To: Mike Giampa 110 Laurier Avenue West, 4th Floor Ottawa, ON K1P 1J1 File: 6420 Ottawa Street – Mattamy Richmond Village	From: Lauren O'Grady, P.Eng. 400 – 1331 Clyde Avenue Ottawa, ON K2C 3G4 Date: September 9, 2019
--	---

Reference: 163600873 – Mattamy Richmond Village

In June 2019 Stantec Consulting Ltd. (Stantec) prepared the *Richmond Subdivision Transportation Brief Update* on behalf of Mattamy Homes (Mattamy) for a proposed residential development located in Richmond Village. In August 2019 Stantec received comments from the City of Ottawa.

Attachment 1 – Revised Draft Plan (September 9th, 2019)

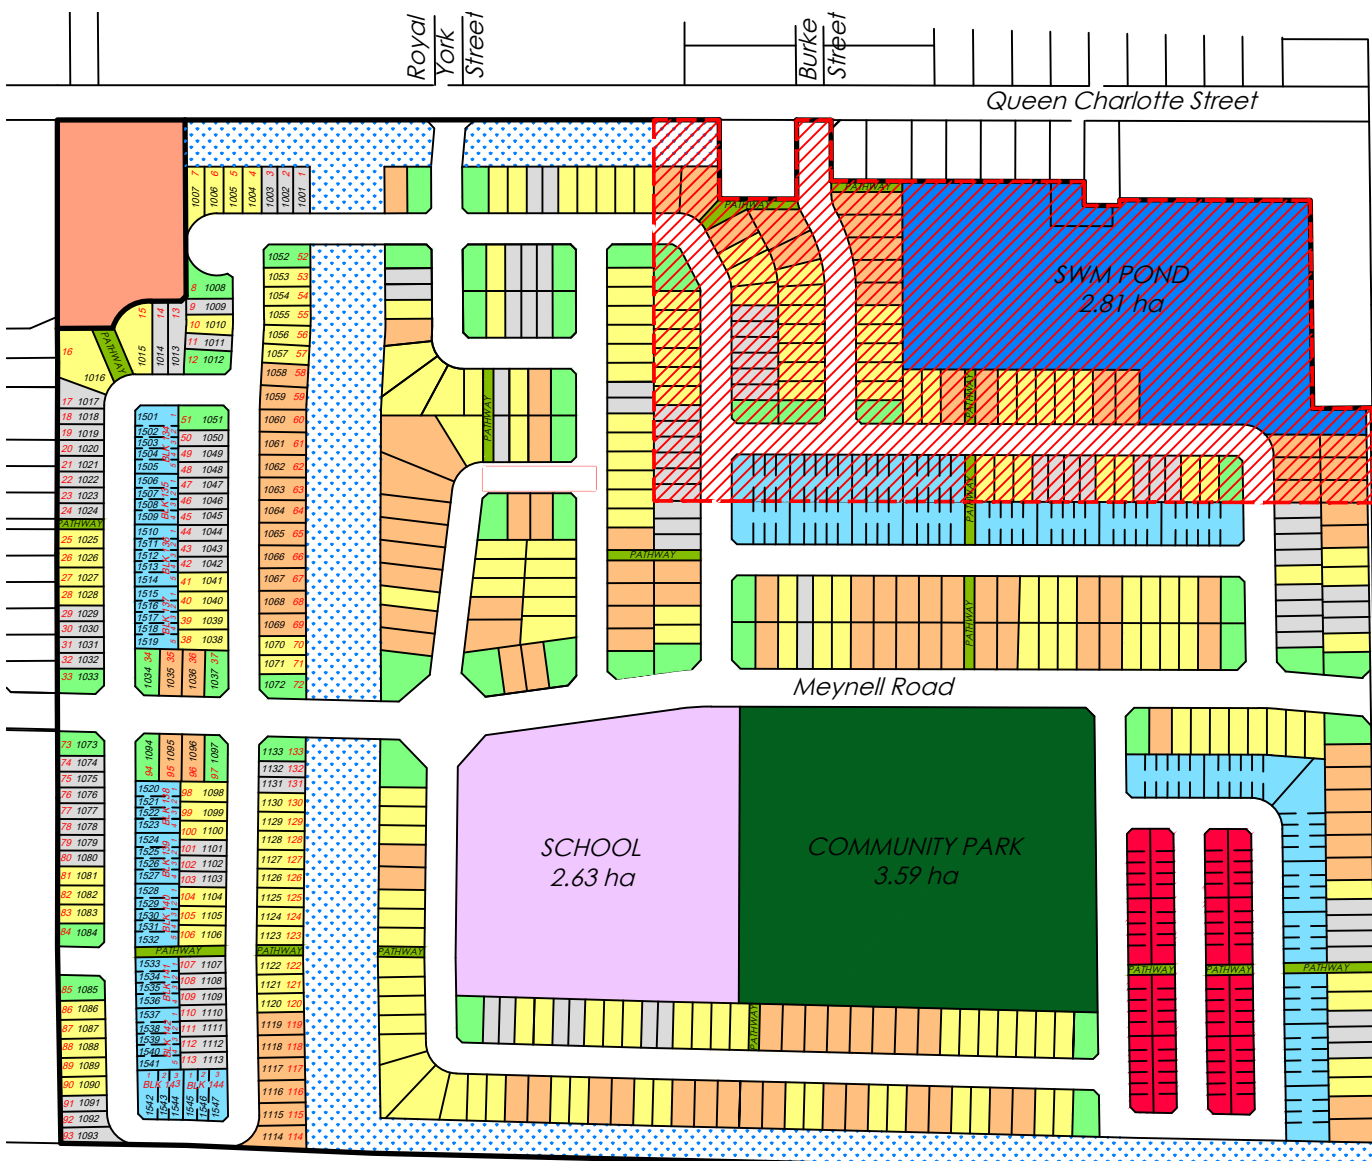
14	<p>The proposed bus stop location on the east side of Meynell opposite the school conflicts with the front-facing homes. In this configuration, it will not be possible to provide adequate bus stop infrastructure.</p> <ul style="list-style-type: none">Consider rotating the lots highlighted below to face the side streets, leaving a side-lot along Meynell which can accommodate a bus stop and/or other utilities. 	<p>These lots have been reoriented to accommodate the required bus stop infrastructure. The revised Draft Plan can be seen in Attachment 1.</p>
----	---	--
